**RFCP-007 - SDF EXHAUST FAN MODIFICATION
SHEET 3 - M02**

CINCINNATI, OHIO
METROPOLITAN SEWER DISTRICT
SSO 700 STF DISINFECTION IMPROVEMENTS
MECHANICAL
SDF HVAC FLOOR PLAN

PROJECT NO.
402259
M-02
SHEET
31 OF 58

OPERATING FLOOR LEVEL - HVAC PLAN
1/4" = 1'-0"

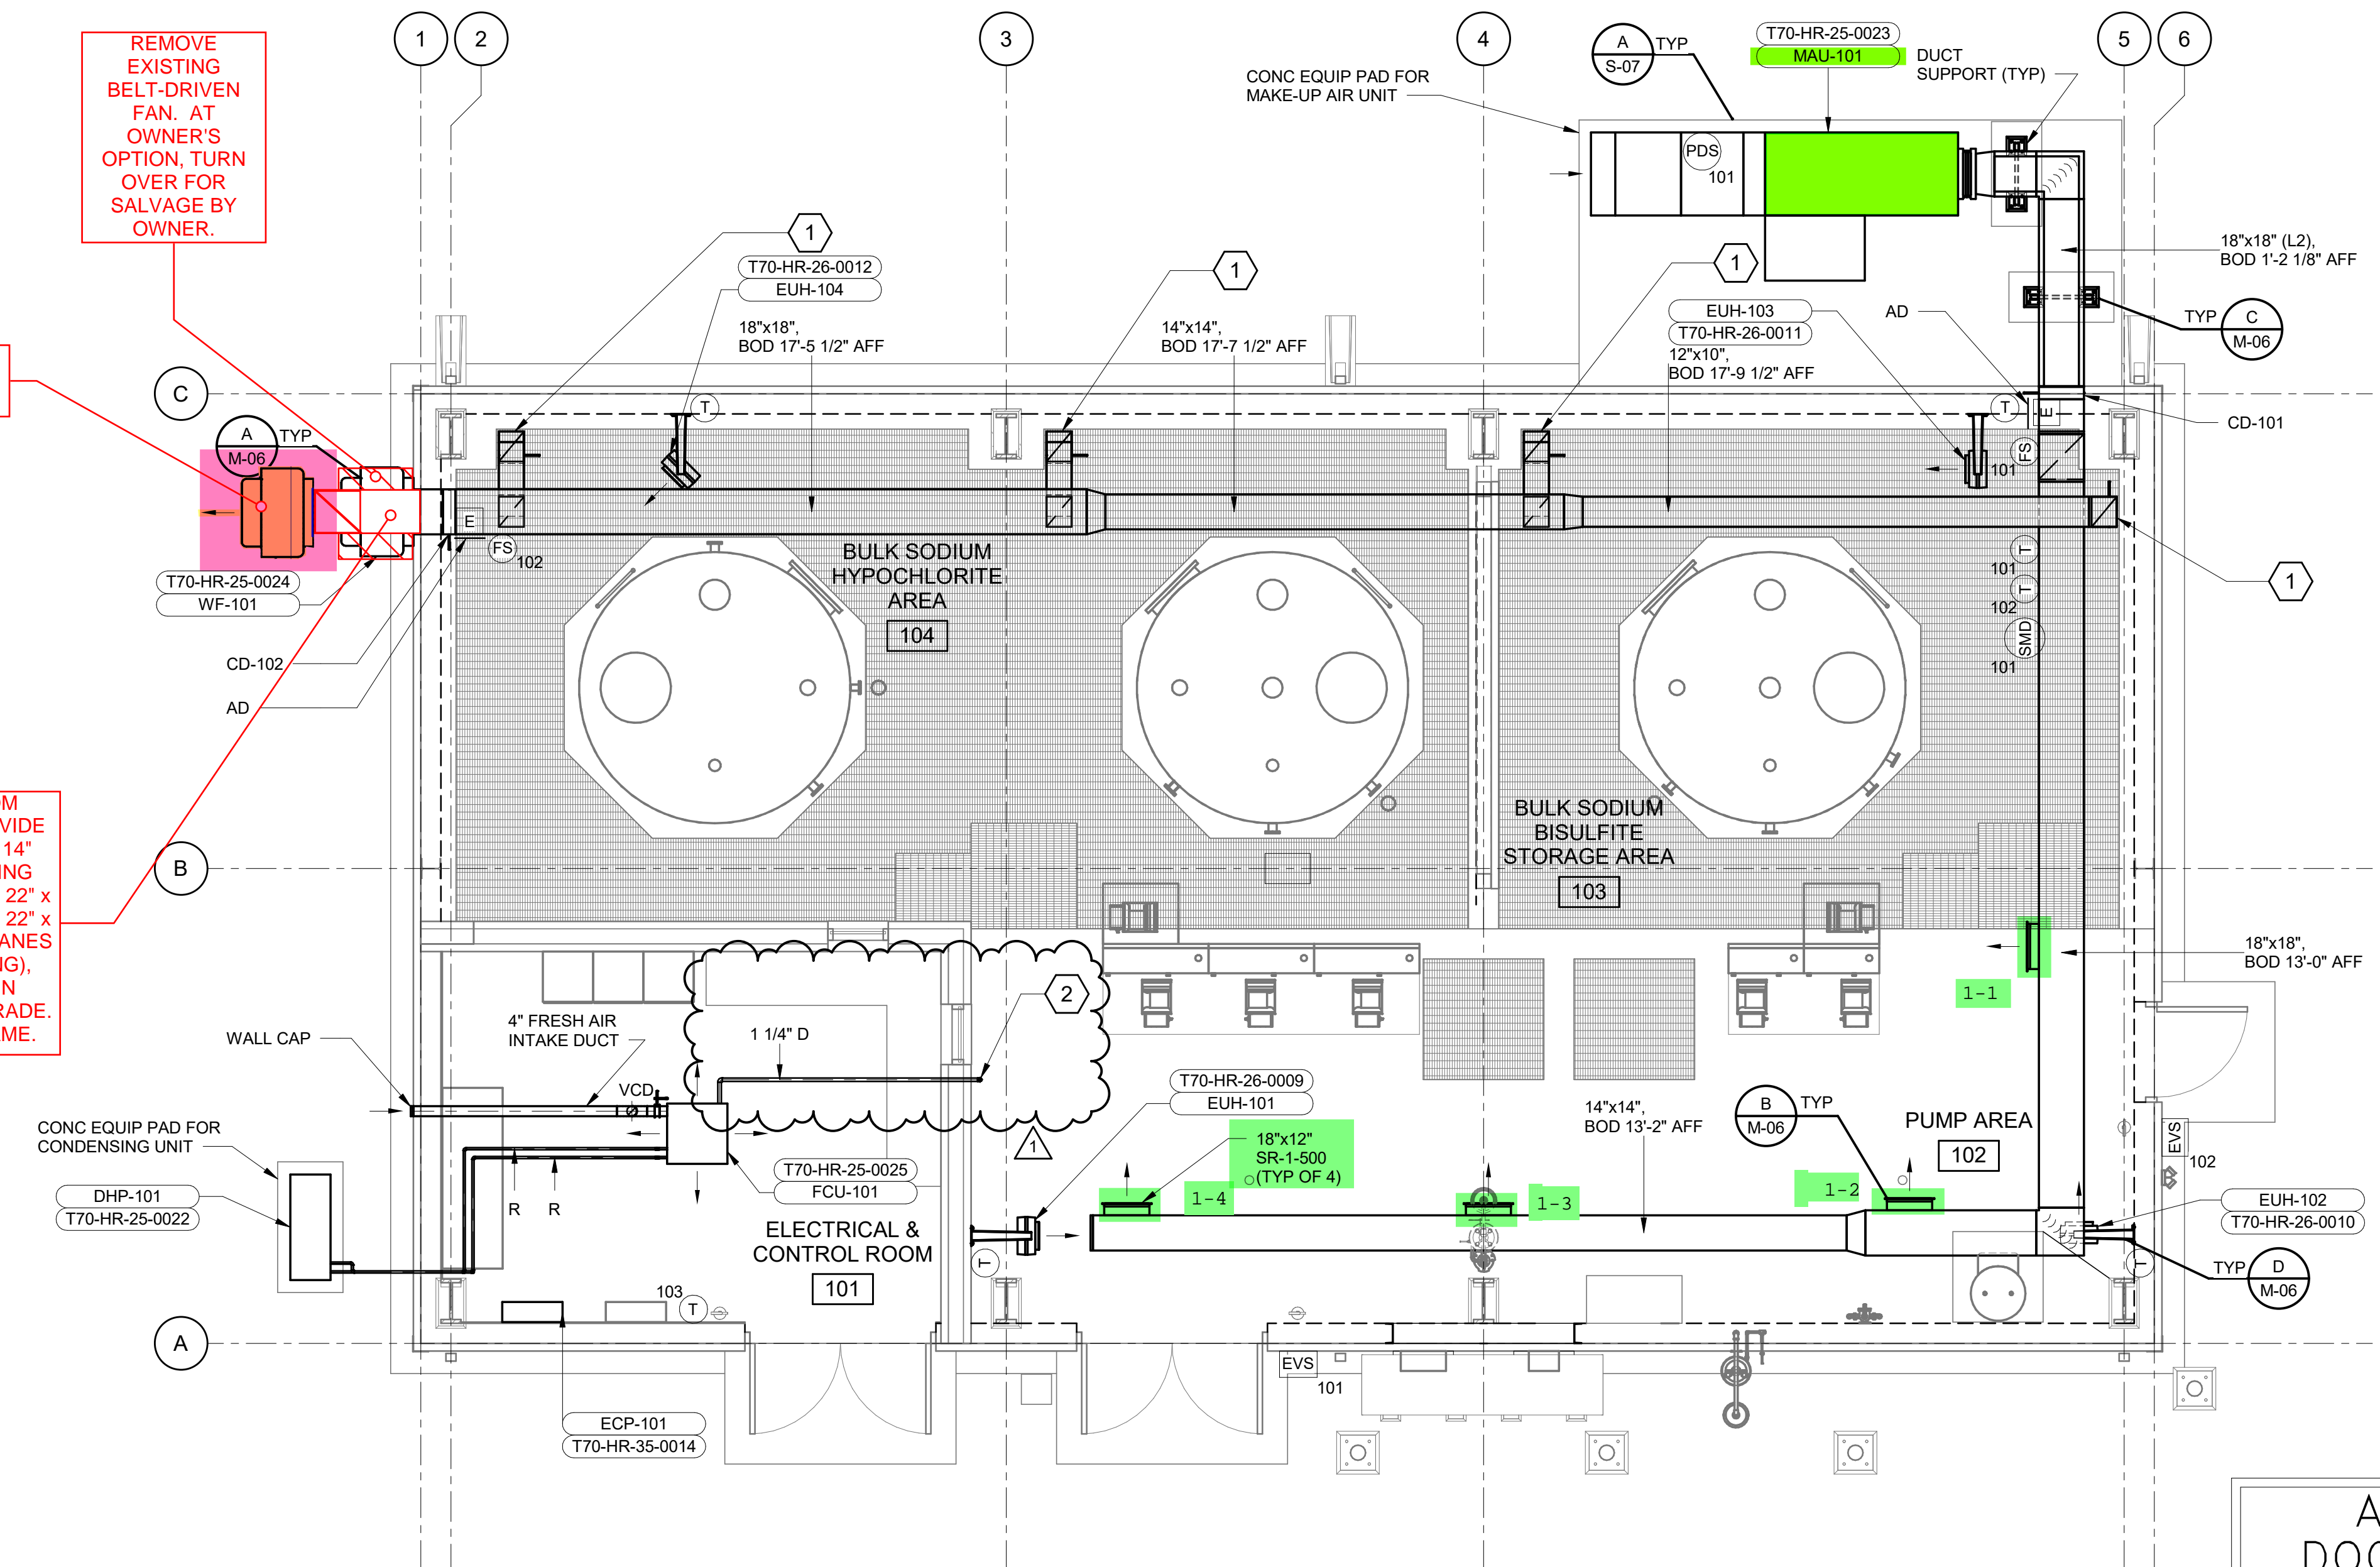
- 12"x10" EXHAUST DUCT DN TO 1'-0" ABOVE CONTAINMENT FLOOR, COVER OPENING W/ 12" SQ. ALUM BIRDSCREEN, PROVIDE VCD @ 5'-0" ABOVE GRATING, SET @ 500 CFM.
- 1 1/4" CONDENSATE DRAIN TO FR, SEE PLUMBING DWG.
